**SUBMISSION TO MANGOOLA MINE EA
ON BEHALF OF PROPERTY OWNERS OF
RIVERSLEA, WYBONG PARK, WYBONG ESTATE,
DOLWENDEE AND HOLLYDENE ESTATE**

Report No: 131062_Rep_Final
June 2013
(Released: 28 June 2013)

This section presents the findings of the objective review undertaken of the *Mangoola Coal Project – Modification 6 Noise and Vibration Assessment* released on 22nd May 2013.

Figure 1-1: Location of additional Receiver

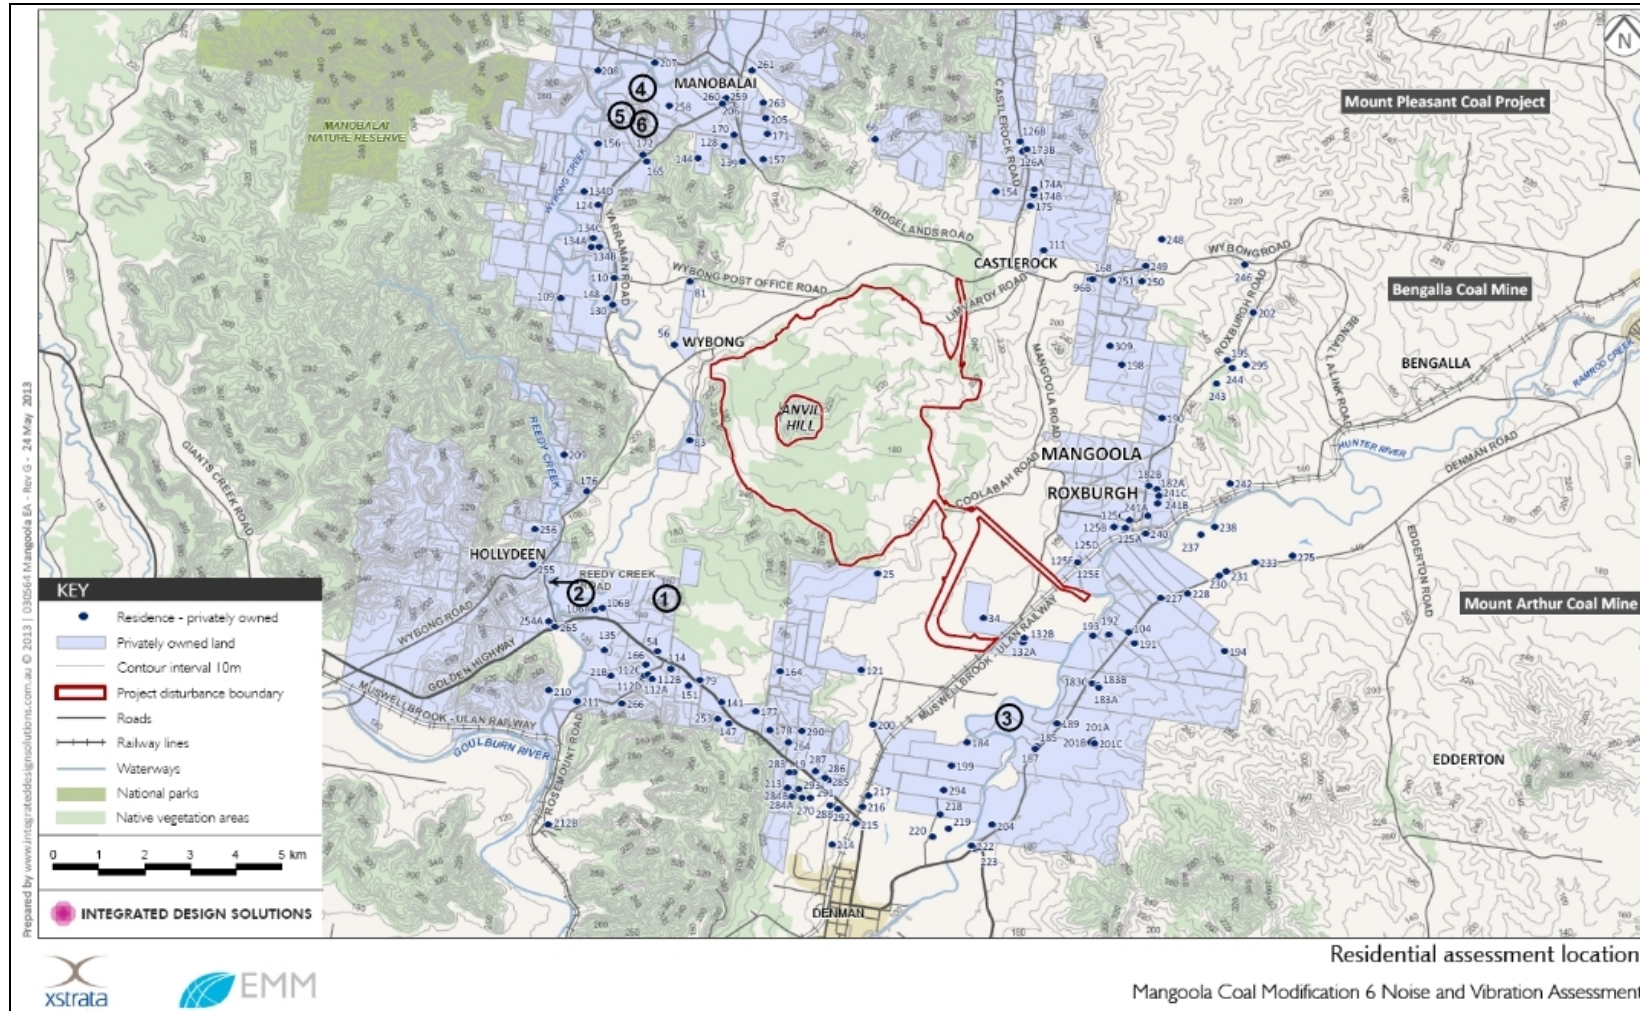
The absence of recently approved land subdivisions on the site layouts in the EA reinforce their doubts.

The additional receiver locations are shown on Figure 1-1.

Some receptors have not been included in the study. For example the two land subdivisions present to the south west of the site identified as Lot 1 and lot 2 DP 1160936 have not been considered in this assessment. Note that a development application for two residential dwellings on the aforementioned lots has been approved in 2011.
